RE: Project Name: Camp Denali – Building 49150 CSMS Floor Resurfacing
Project Number: 02A8022008
Project Location: Camp Denali – Building 49150 CSMS, JBER, Alaska

Addendum # One (1)

REFERENCE FLOOR PLAN
1/16"=1'-0"

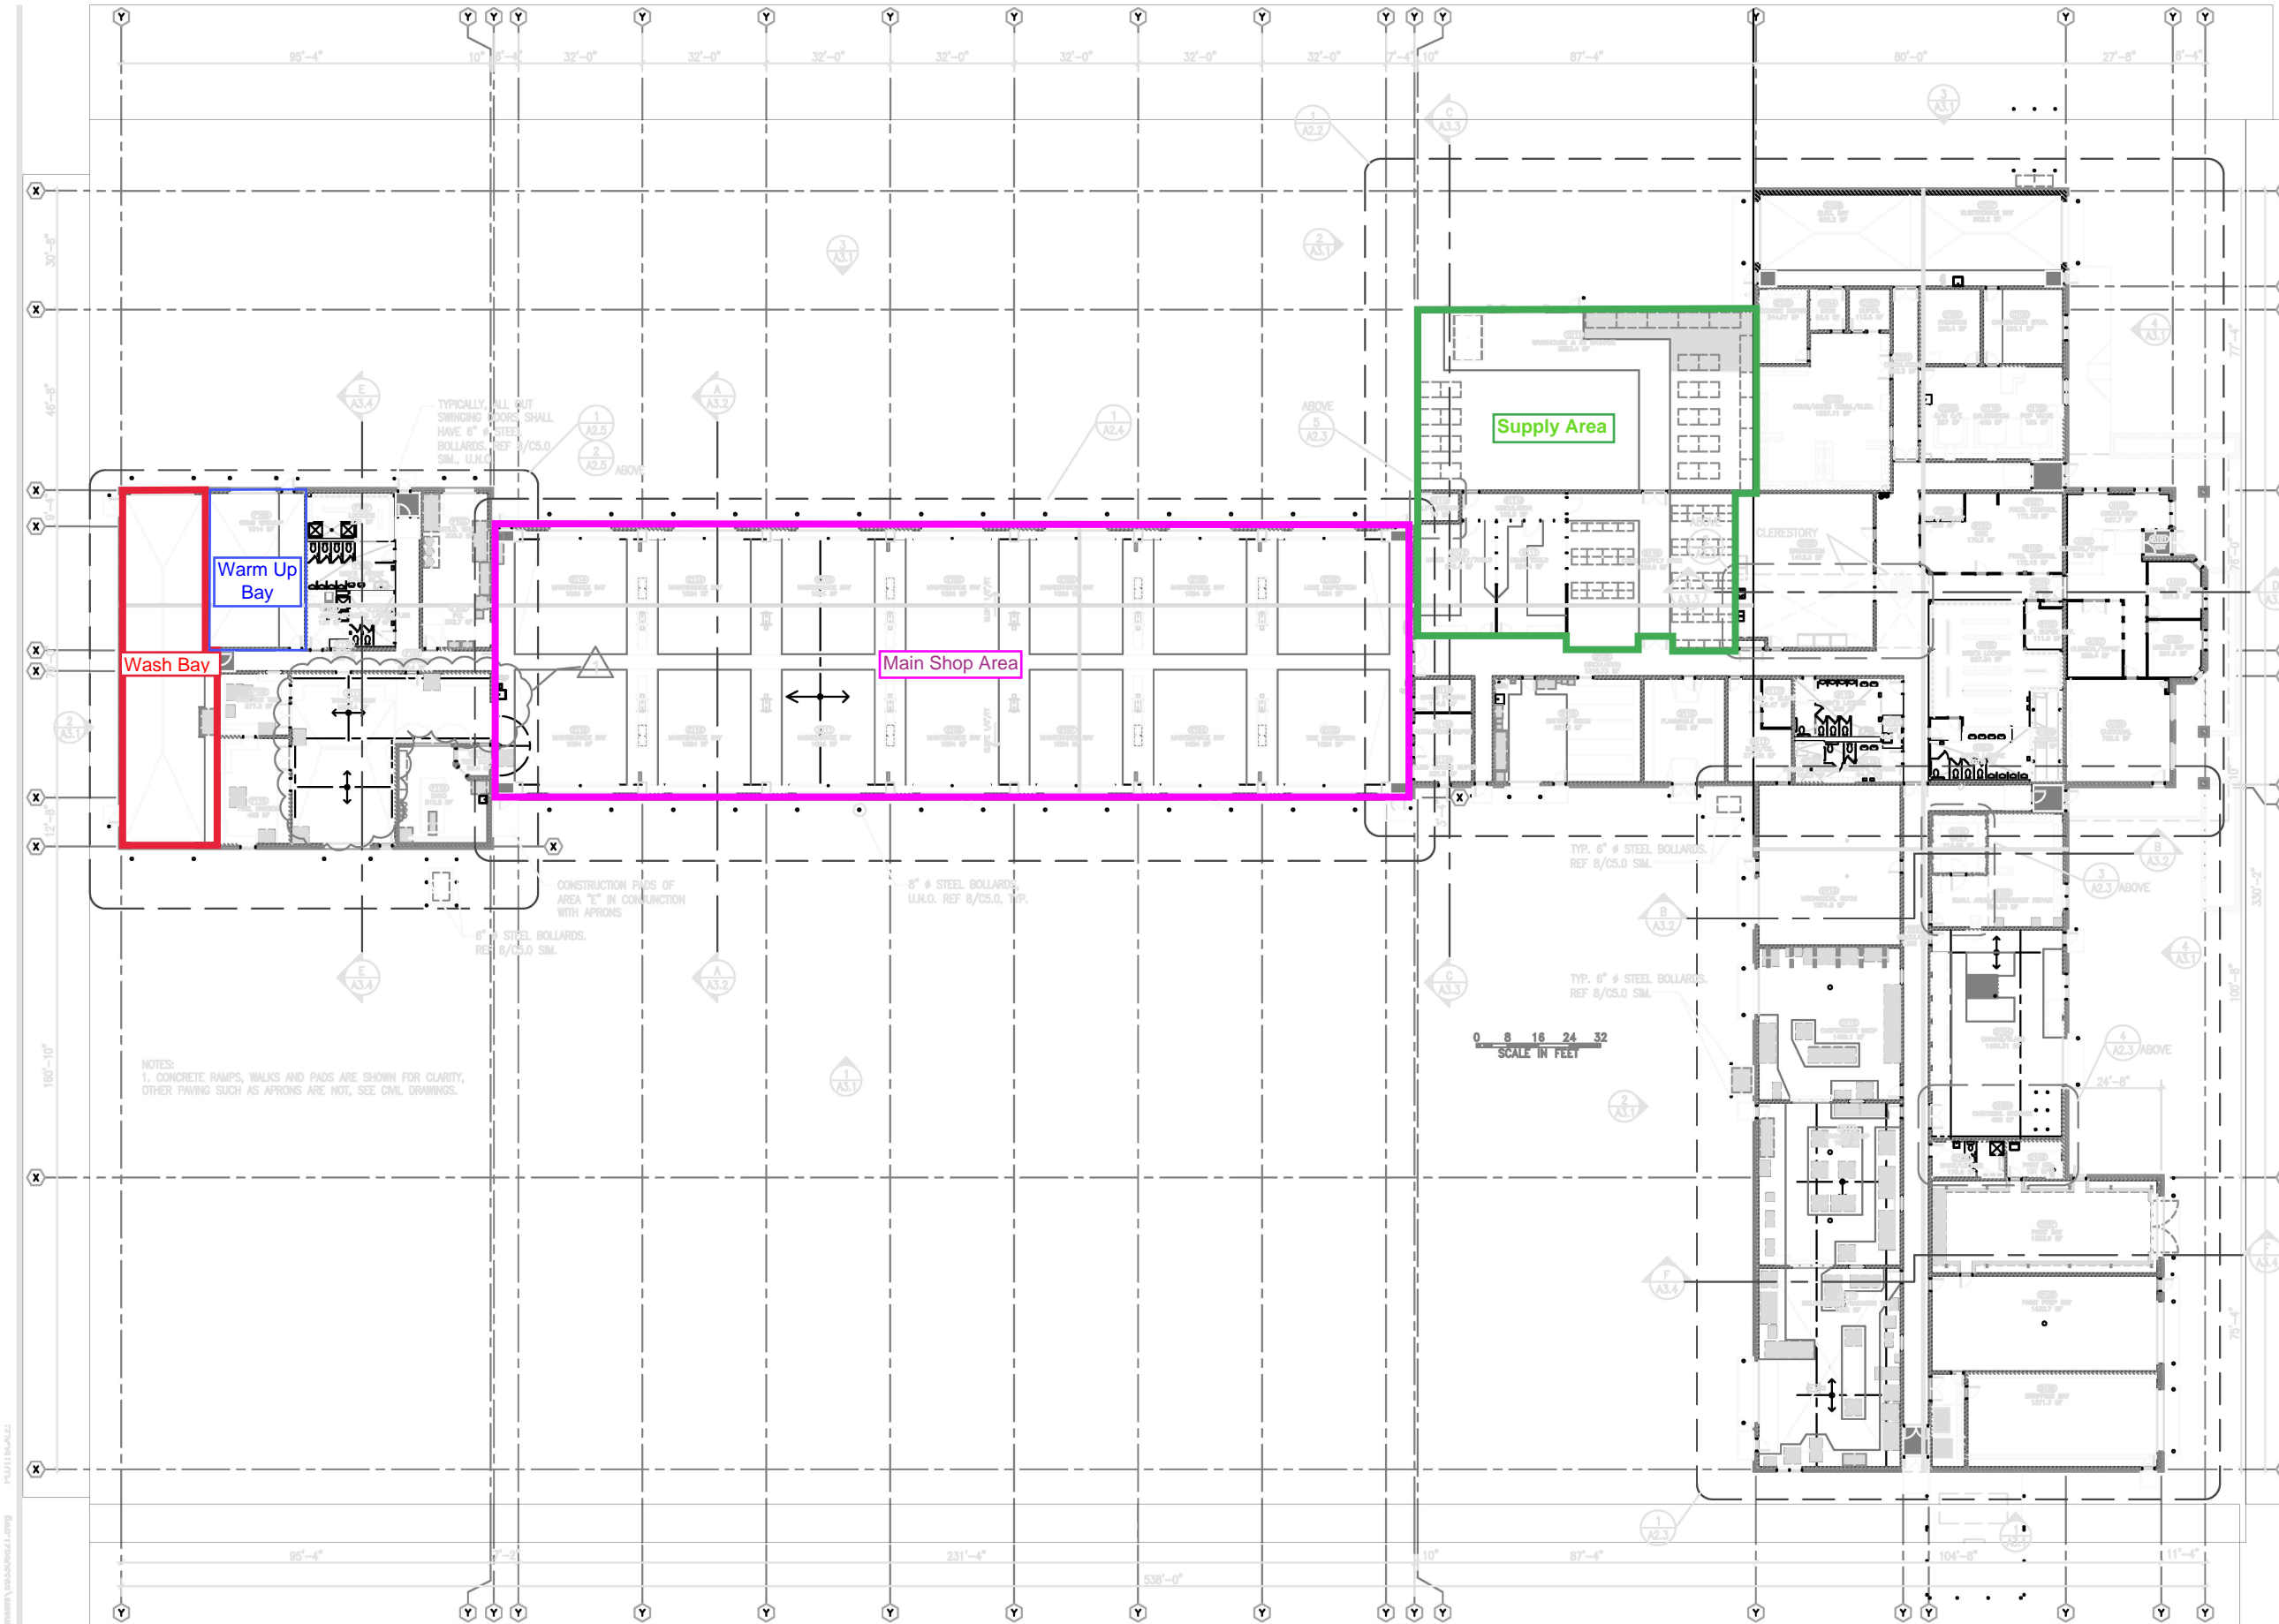
Question 1: Curious, will you be providing a floor plan with this posting?

Question 3: Could you clarify which area is the "warm up bay" listed in **Add alt. Option 2** of section **1.02 Work Covered By Contract?**

Question 4: Could you clarify which area is the "**Supply area**" listed in Add alt. Option 3 of section **1.02 Work Covered By Contract**

Answer 1: Please see attached Floor Plan (may not be to scale).

Answer 3: Please see attached Floor Plan with the "warm up bay" called out.

Answer 4: Please see attached Floor Plan with the "Supply area" called out.
